**FEDERAL AVIATION ADMINISTRATION  
AIRWORTHINESS DIRECTIVES  
SMALL AIRCRAFT, ROTORCRAFT, GLIDERS,  
BALLOONS, & AIRSHIPS**

**BIWEEKLY 2003-06**

Figure 1. Preflight Check of the Tailboom

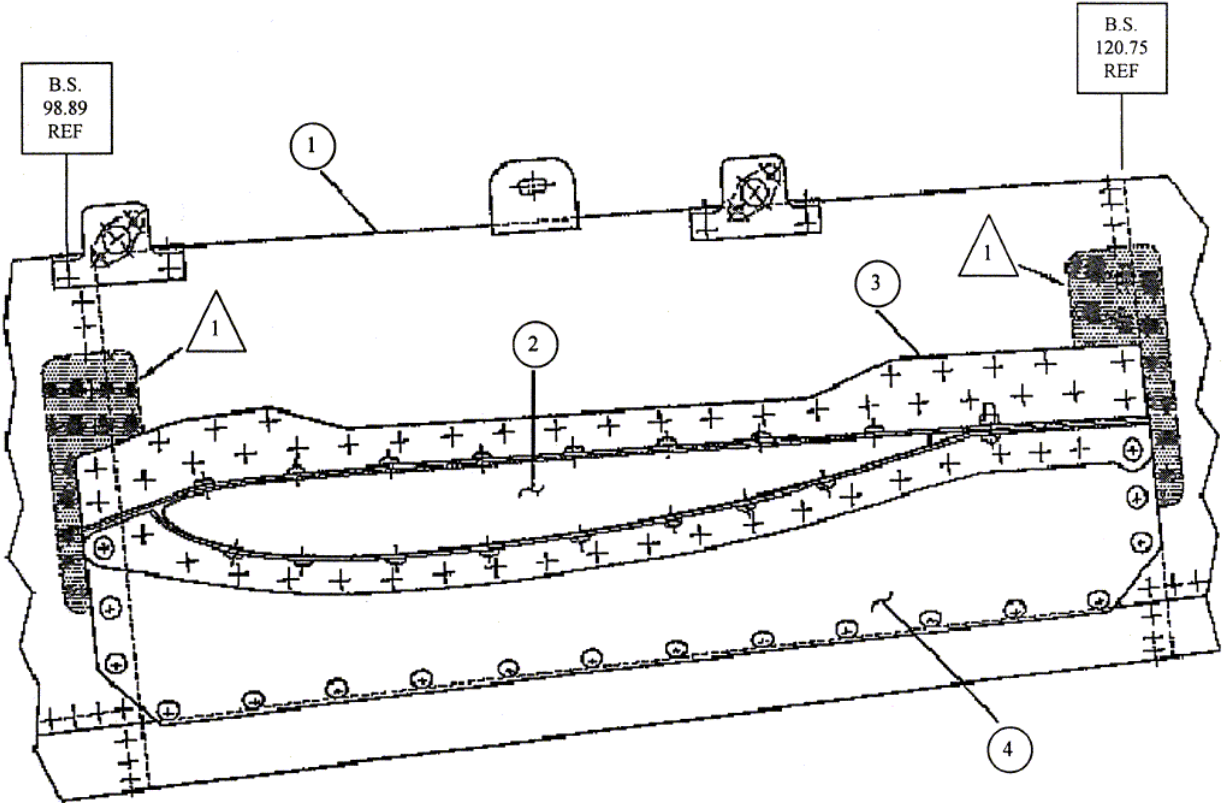
<b>Applicable tailboom</b>	<b>Compliance time</b>	<b>Actions</b>	<b>In accordance with</b>
(a) Tailboom, P/N 407-030-801-101 and -105, that have not been modified in accordance with Bell ASB 407-01-048, Revision B, dated April 25, 2002.	Before the first flight of each day	Visually check the tailboom for cracks. An owner/operator (pilot) holding at least a private pilot certificate may perform the visual check required by this paragraph, but must enter compliance with this paragraph into the helicopter records in accordance with 14 CFR 43.11 and 91.417(a)(2)(v).	Figure 1 of this AD.

- △ 1 Examine these areas for cracks on left side of tailboom only.
- 2. Horizontal stabilizer not shown for clarity.

**Figure 1. Correct cup washer direction, installation of**

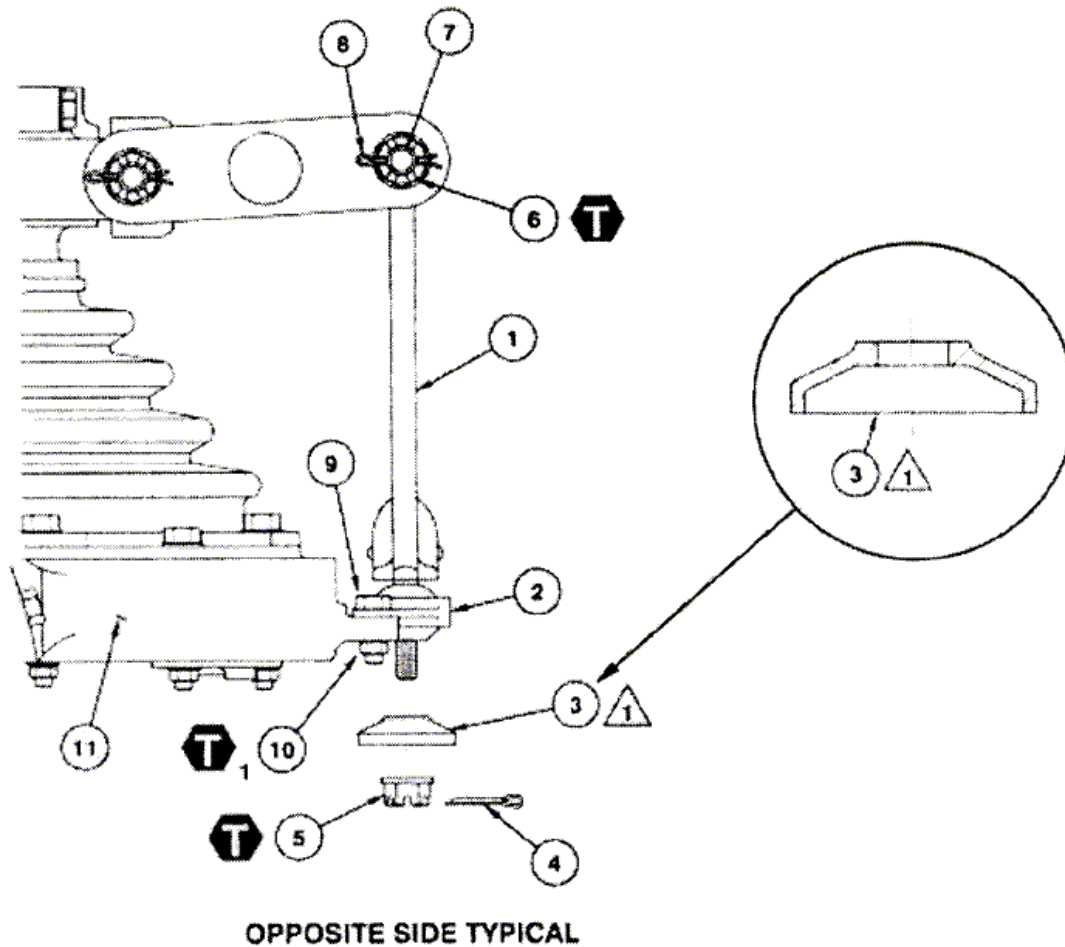
(a) Visually check both cup washers, part number (P/N) 406-010-412-101, for correct installation in accordance with Figure 1 of this AD. If both cup washers are installed correctly, no further action is required. This visual check may be performed by an owner/operator (pilot) holding at least a private pilot certificate, and must be entered into the aircraft records showing compliance with this paragraph in accordance with sections 43.11 and 91.417(a)(2)(v) of the Federal Aviation Regulations (14 CFR sections 43.11 and 91.417(a)(2)(v)). See the following Figure 1:

**Note 2:** In Part II, step 3.a. of the alert service bulletin, the swashplate is incorrectly referenced as item 10 of Figure 1. The reference should state item 11.

(b) If a cup washer is installed incorrectly, remove and replace the swashplate outer ring, each cup washer, bearing and liner, and drive link where the cup washer was installed incorrectly. Replace these parts in accordance with Part II of the Accomplishment Instructions in Bell Helicopter Textron Alert Service Bulletin No. 407-02-55, dated October 29, 2002.
